Access Compliance Report

Public Rights-of-Way

(Curb Ramps)

Intersection ID: 7087	Main Street: COTTAGEVILLE_LN	Cross Street: MELYNDA_RD	Location:	N
ADA ID: 4F0A412E63FF	Ramp Type: Perp	Initial Pass/Fail: Fail	Overall Compliance: No	Severity Score: 21.25

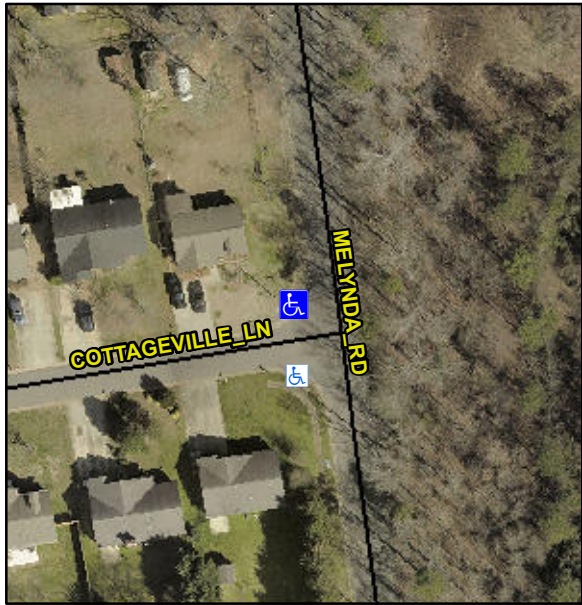
Codes/Mitigation Info/Possible Solution			Field Measurements/Component Compliance					
	Possible Solutions:		Compliance	Description	Data	Compliance	Description	Data
	Remove & Replace Entire Ramp.		N/A	Ramp Length (in)	48.0	No	Ramp Slope (%)	10.7
			No	Ramp Width (in)	45.0	Yes	Ramp XSlope (%)	0.1
			N/A	Flare Type LT	N/A	N/A	Flare Type RT	N/A
			N/A	Flare Slope LT (%)	N/A	N/A	Flare Slope RT (%)	N/A
			N/A	Flare Traversable LT?	N/A	N/A	Flare Traversable RT?	N/A
			N/A	Landing Length (in)	N/A	N/A	DWS Provided?	N/A
			N/A	Landing Width (in)	N/A	N/A	DWS Contrast?	N/A
			N/A	Landing Slope (%)	N/A	N/A	DWS Length (in)	N/A
			N/A	Landing X Slope (%)	N/A	N/A	DWS Full Width?	N/A
Surveyor Notes:			N/A	Landing Curb? (Y/N)	N/A	N/A	DWS Offset (in)	N/A
N/A			N/A	Shared Landing?	N/A			
PROW/ADA:			N/A	Gutter Ponding?	N/A	N/A	Gutter Slope (%)	N/A
Not Found, R304.5.1, R304.2.2			N/A	Gutter Lip Ht (in)	N/A	N/A	Gutter X Slope (%)	N/A
